Submission Regarding SSD-77608714-Mod-2

Modification 2 to increase building height and other external modifications 1 Darling Point Road, Edgecliff

Dated: 26.05.2026

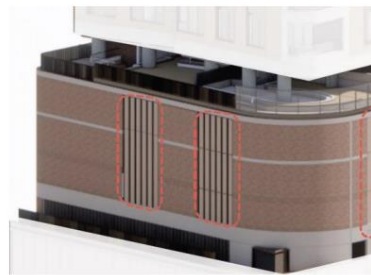
Based on our assessment of the plans, the openings appear to be approximately 20–30 cm wide. Given the extremely close proximity of the structures - approximately 3 metres from our apartment windows - these openings will permit direct lines of sight from the adjoining car park area into our private living spaces, including:

- the lounge room;
- the dining area; and
- the main bedroom.

Figure 3 Approved vs Proposed Northern and Eastern Carpark Façade

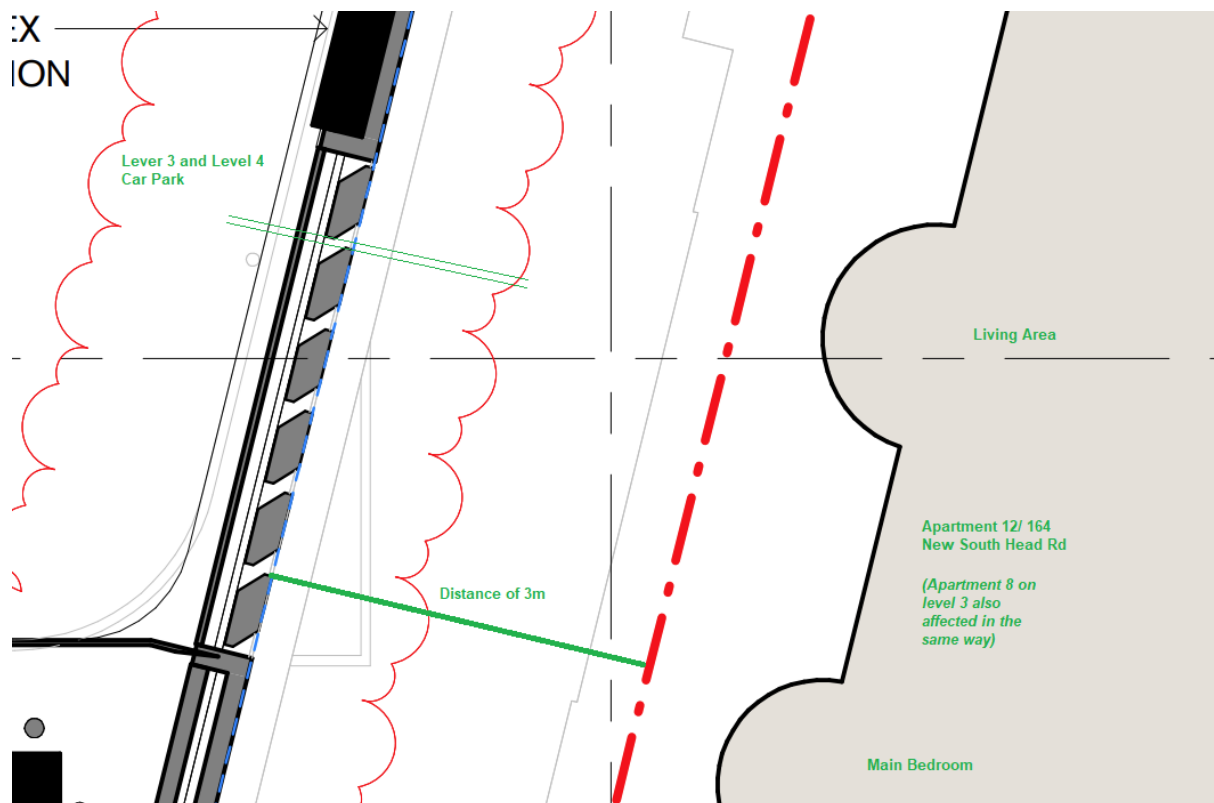
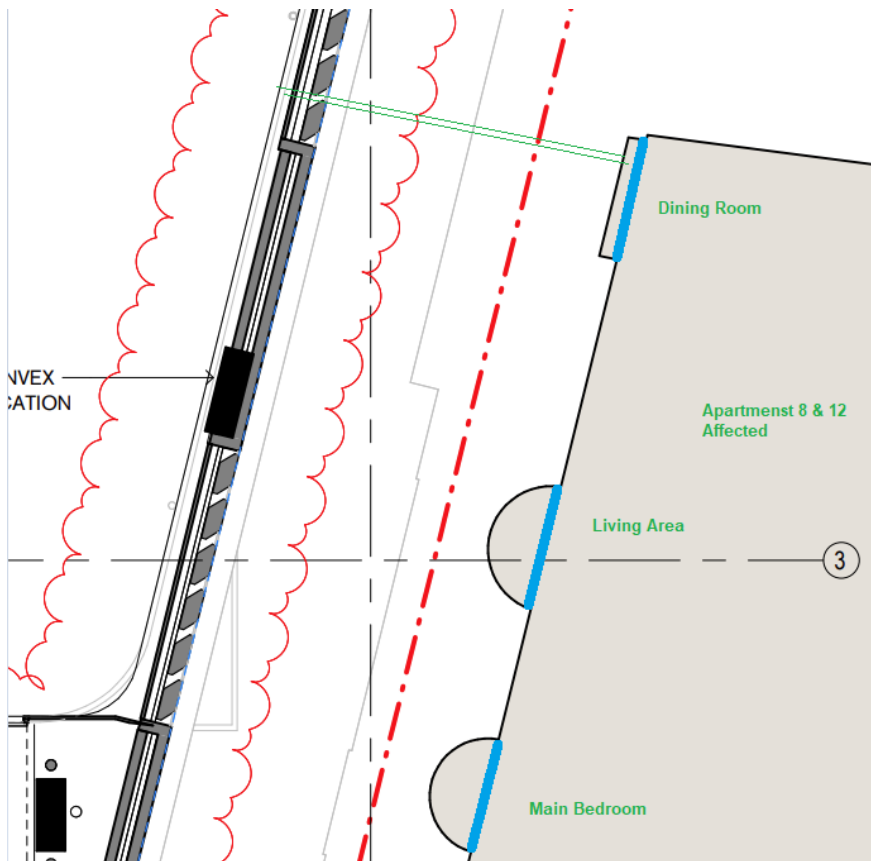
The proposed amendment introduces substantially wider gaps between the façade louvers, as indicated in the drawings submitted with the application.

This represents a serious and unacceptable invasion of privacy for residents of the adjoining building. The originally approved façade design provided appropriate visual screening and directional shielding. The proposed amendment materially weakens those protections.

The originally approved façade treatment appeared specifically designed to redirect light spill and vehicle noise laterally, thereby minimising impacts on neighbouring residents. The proposed amendment undermines that design intent by creating direct openings facing residential windows.

The widened louvre gaps create direct and unreasonable privacy impacts, compromise residential security, and materially reduce the amenity of adjoining apartments through increased noise and artificial light intrusion.

These impacts are avoidable. Eliminating the frontal gaps and fully redirecting the openings to the side, consistent with the intent of the originally approved design, would address the concerns raised above.

We therefore request that the proposed modification be refused unless the façade design is amended to eliminate direct openings toward adjoining residential apartments and restore adequate privacy and acoustic/light screening outcomes.
